# Planning Commission Staff Report

**Application:** PL-17-03526  
**Subject:** Empire Residences  
**Author:** Kirsten Whetstone, AICP, Sr. Planner  
**Date:** January 10, 2018  
**Type of Item:** Administrative - Conditional Use Permit

Staff recommends the Planning Commission hold a public hearing, discuss compliance with the Village MPD Volumetrics, and consider approving a Conditional Use Permit for the Empire Residences (Building 3 -Village at Empire Pass Master Planned Development) according to the findings of fact, conclusions of law, and conditions of approval as outlined in this report.

DRAWING NUMBER  
**AS100**

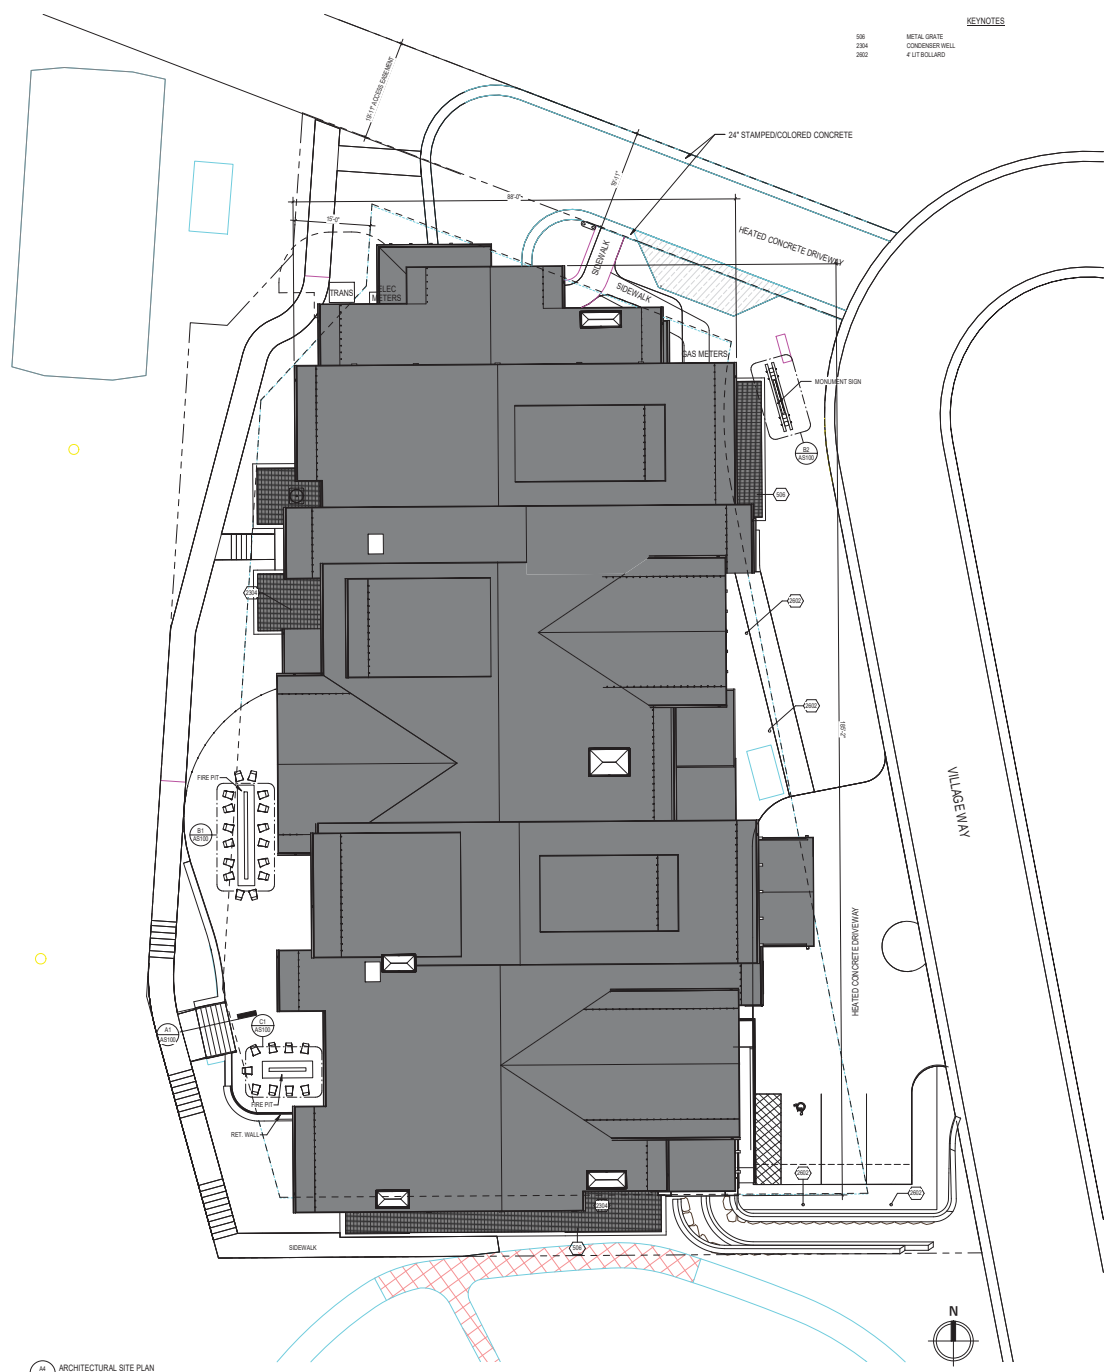
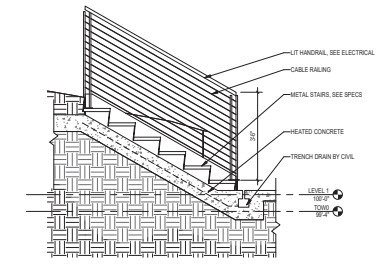
1. The review was based on plans dated 08.xx.2017 and printed 9.21.17 prepared by BWA Architects and now on file except for:
  - Site Plan Sheet AS100 printed 10.18.17 now on file;

3. The applicant has shown on the site plan the designated surface parking spot for the adjacent lot on the north driveway; the parking stall should meet city requirements for stall size and dimensions should be shown on the site plan for location and size.

39. Construction management plan will be submitted and reviewed/approved prior to commencement
40. The entry monument specs and pics have been submitted and approved prior and are shown on Detail B2 Sheet AS100.
